New Stream Header work item questions

Ashley Butterworth
Apple Inc

Original Proposal

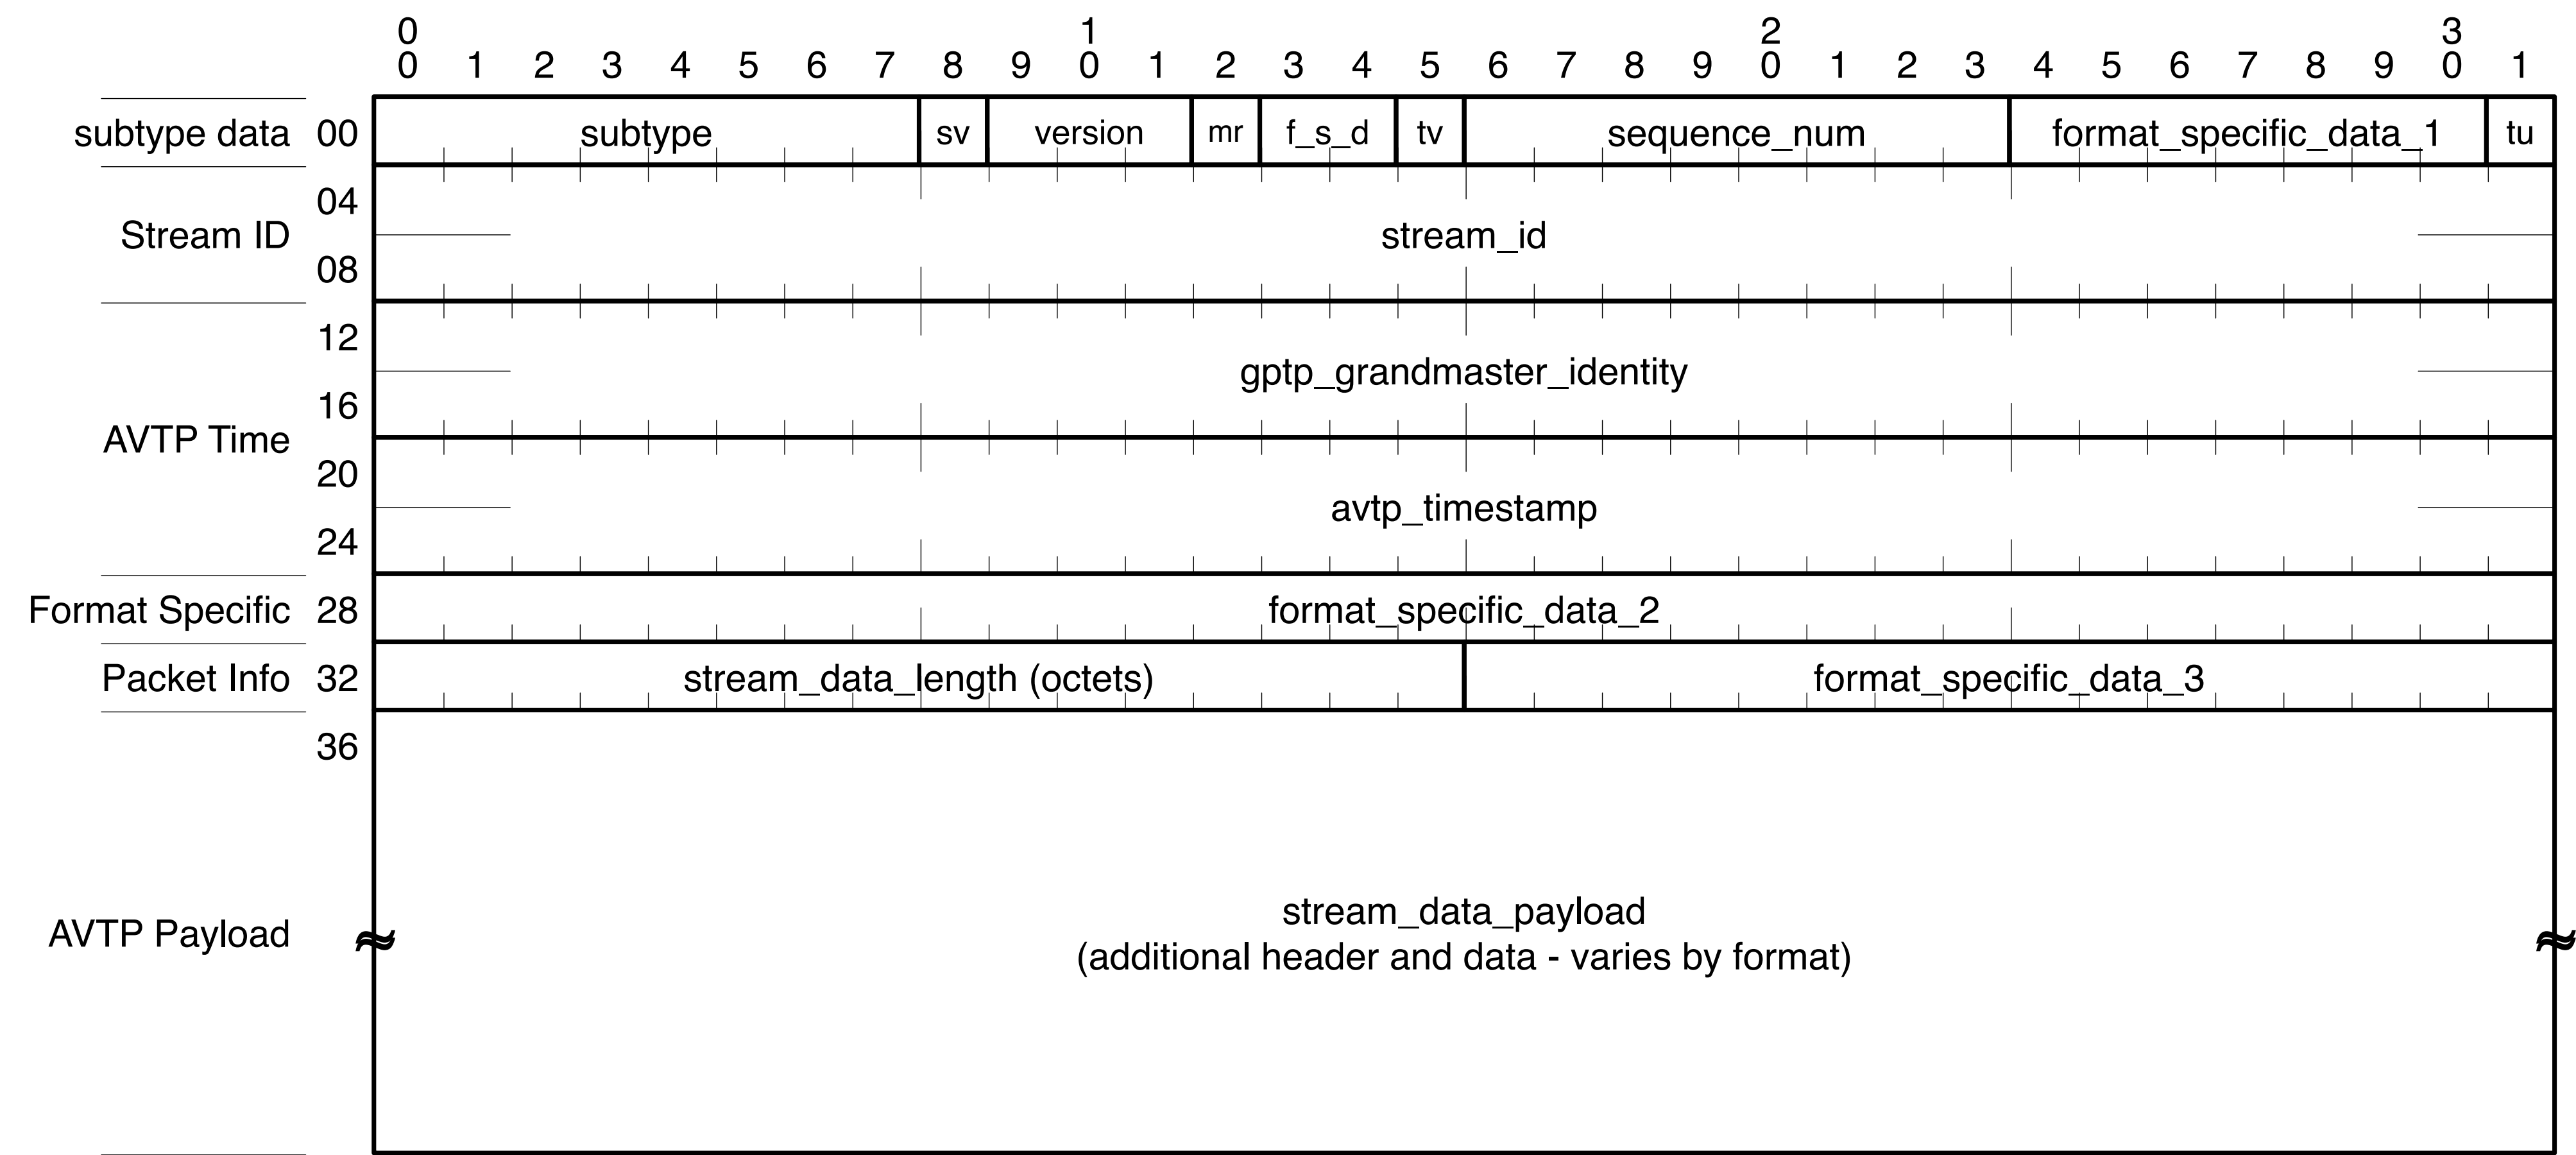
New Stream Header

Updated Proposal

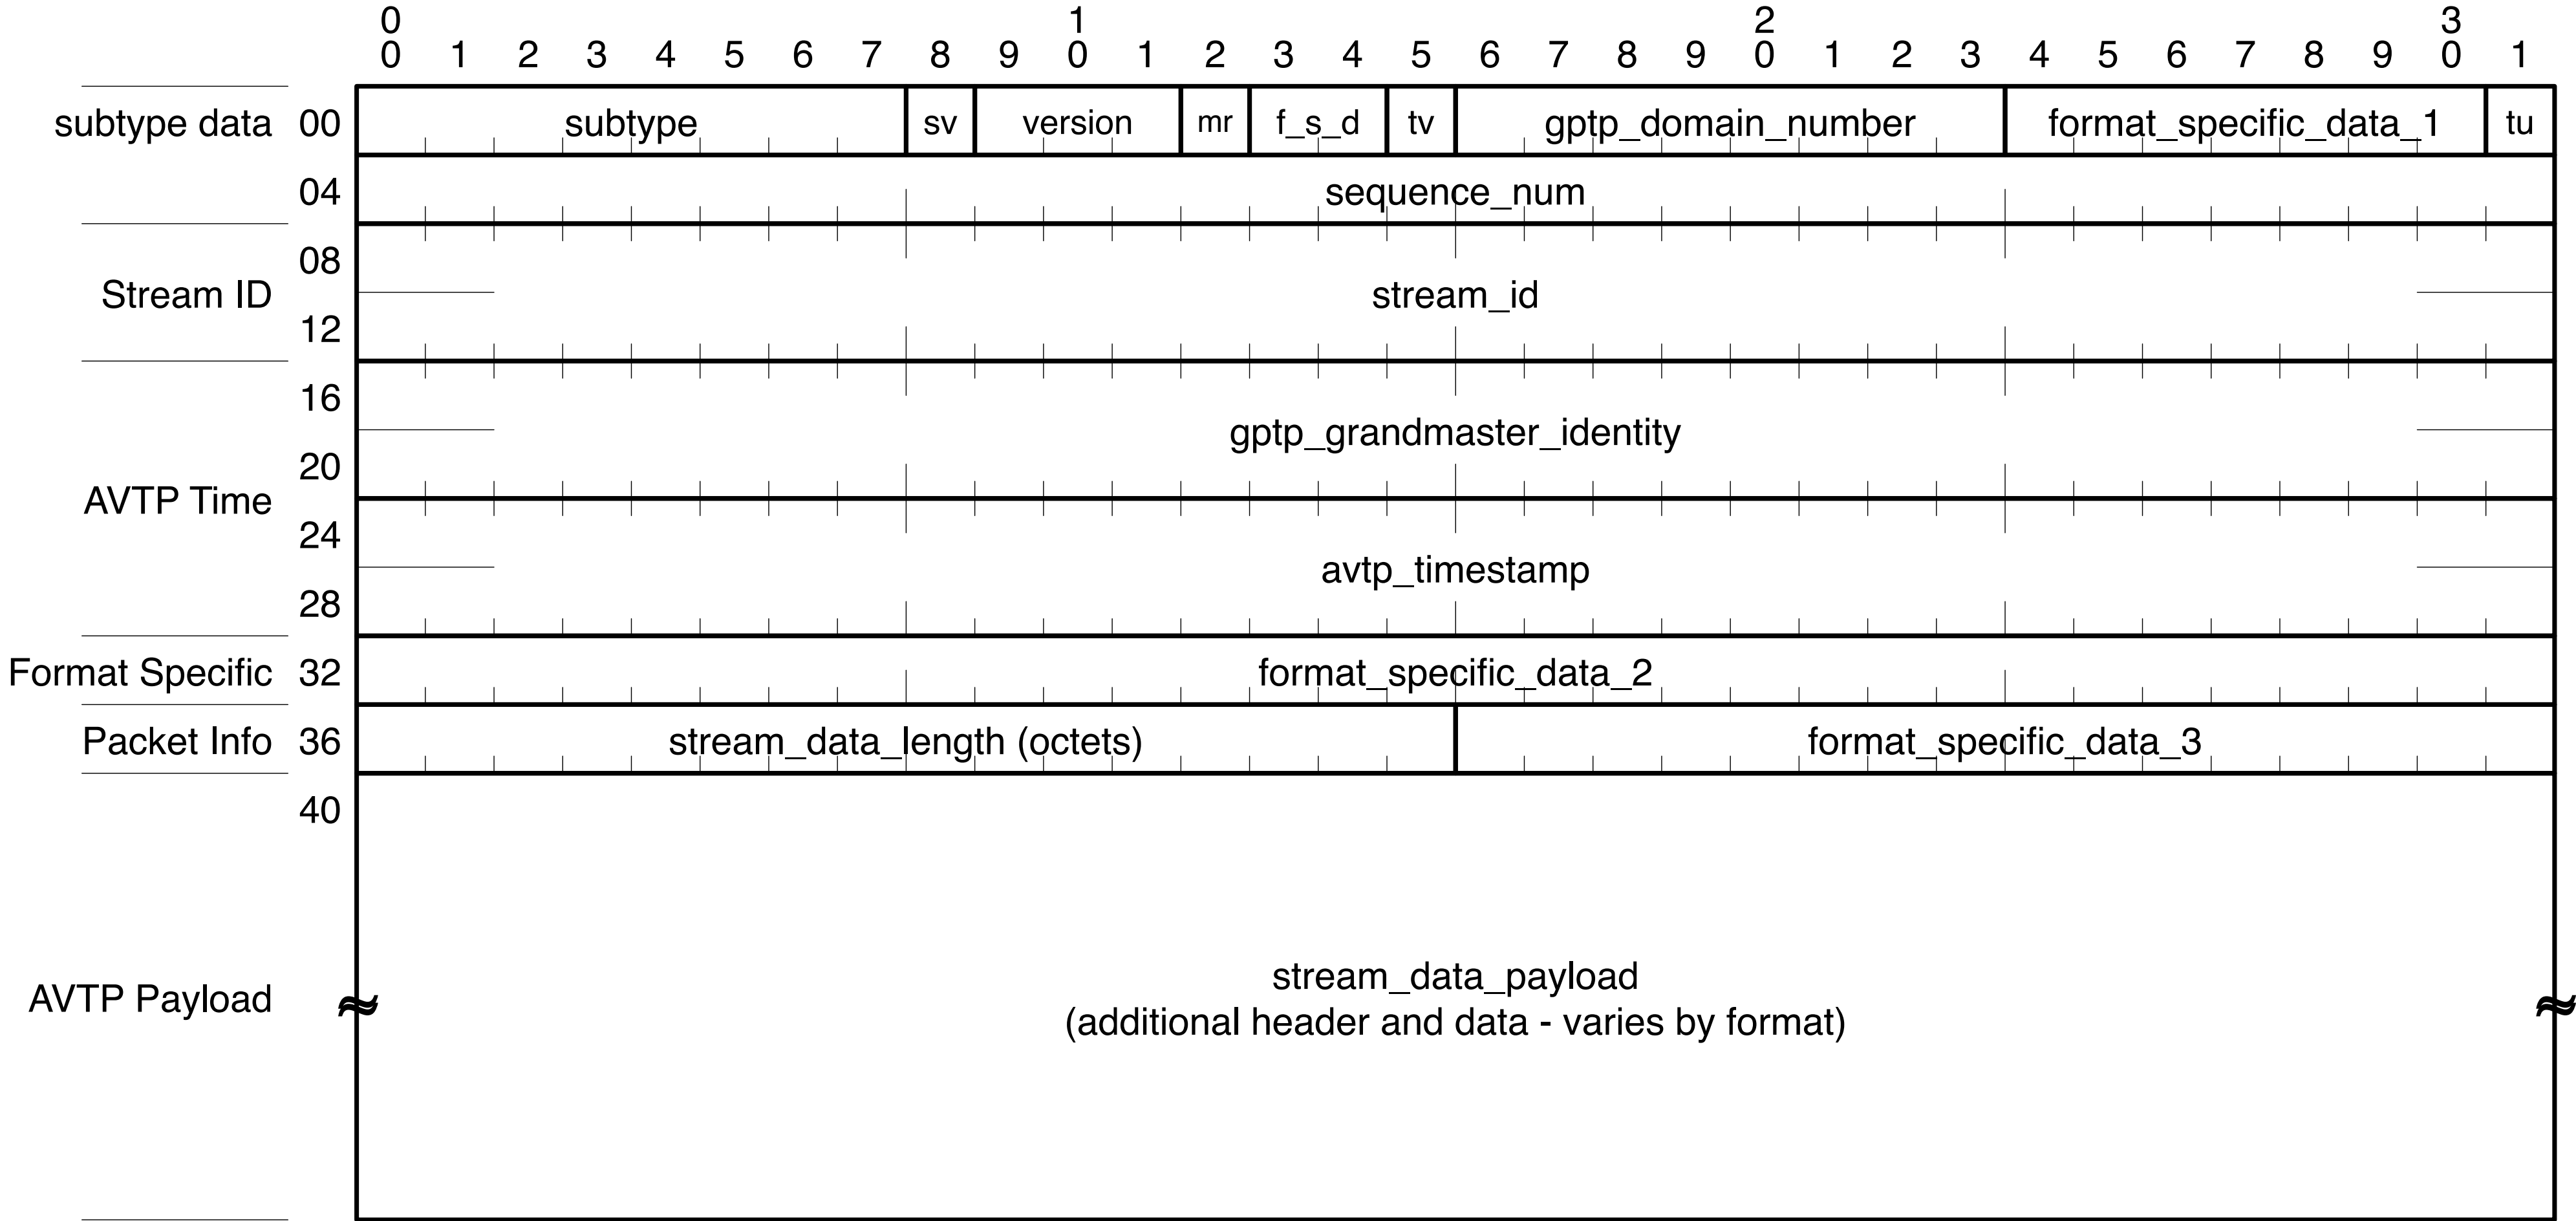
V1 Header and CRF

- CRF uses alternative header and adds it's own definitions for stream ID, etc.
- This will require CRF to define it's own version 1 header with the additional fields
